ADDENDUM NUMBER 1

CRIMINAL JUSTICE FACILITY
COOLING TOWER REPLACEMENT
Site #240, Bldg. #76
949 North 9th Street
Milwaukee, WI 53233

Project Number: C103-13645

Date of Addendum: August 28, 2014

COOLING TOWER SCHEDULE

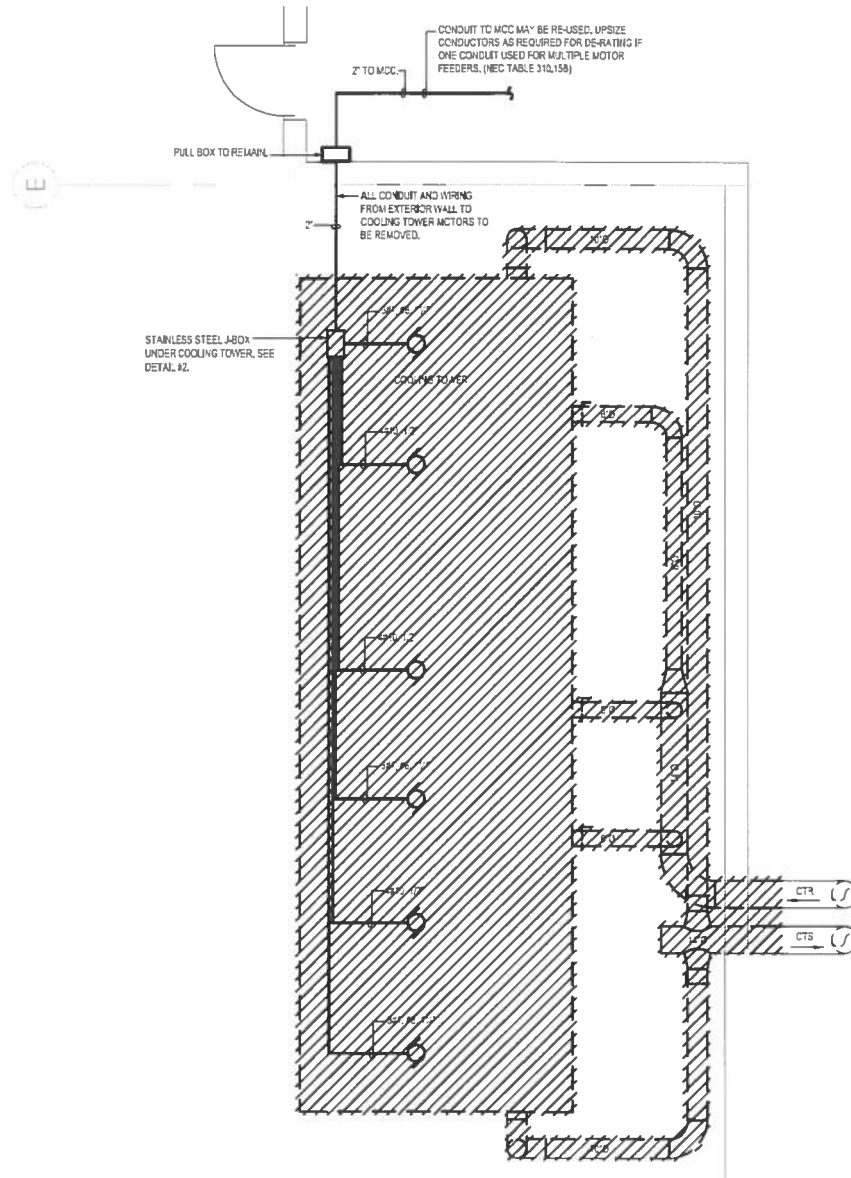
DELETE Section 26 00 00 Electrical Specifications and refer to the book specifications.
DELETE Cooling Tower Schedule and insert in its place Attachment drawing M001A.
INSERT the following new Note to M001: "CONTRACTOR SHALL BE RESPONSIBLE FOR SECURING PERMITS FROM THE CITY OF MILWAUKEE TO SHUT DOWN STREETS AND LIFT ALL EQUIPMENT INTO PLACE."

2 WIRING TO COOLING TOWER (TYP.-2)

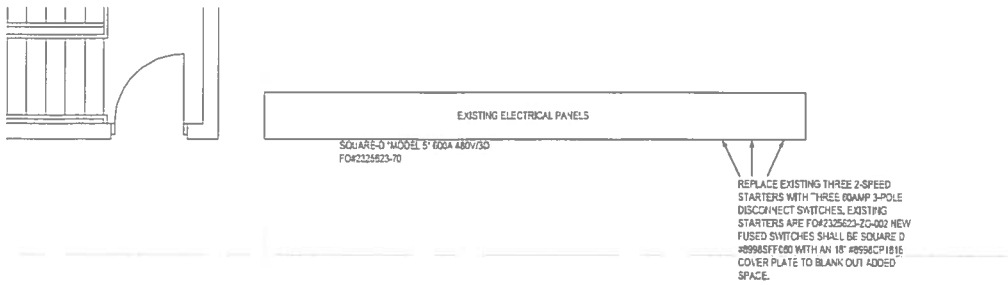
DELETE Partial Cooling Tower and insert in its place Attachment drawing M002A
INSERT Detail 2 WIRING TO COOLING TOWER from Attachment drawing M002A
INSERT Detail 3 INTERIOR PULL BOX LOCATION LOOKING WEST from Attachment drawing M002B
INSERT Detail 4 EXISTING BOX UNDER TOWER from Attachment drawing M002C

- NOTES:**
1. PROVIDE SEALTITE FLEXIBLE CONNECTION TO COOLING TOWER.
 2. DO NOT RE-USE ANY EXISTING SEALTITE CONDUIT.

1 PARTIAL ROOF MECHANICAL NEW WORK PLAN

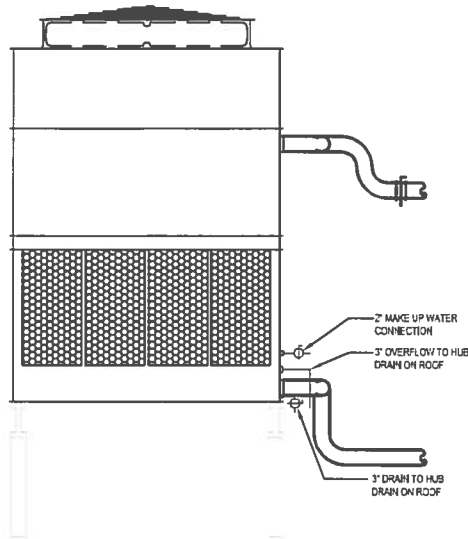
INSERT Details 1, 2 & 3 from Attachment drawing M003A
DELETE Partial Roof Mechanical New Work Plan and insert in its place Attachment drawing M003B
INSERT Detail 2 WIRING TO COOLING TOWER from Attachment drawing M002A
INSERT Detail 3 INTERIOR PULL BOX LOCATION LOOKING WEST from Attachment drawing M002B
INSERT Detail 4 EXISTING BOX UNDER TOWER from Attachment drawing M002C
INSERT a new note on M003 as follows: "A STAINLESS STEEL CAP OVER THE TOP FLANGE OF STEEL SUPPORT WILL BE ACCEPTABLE IN LIEU OF PAINTING THAT PART OF THE FRAME."
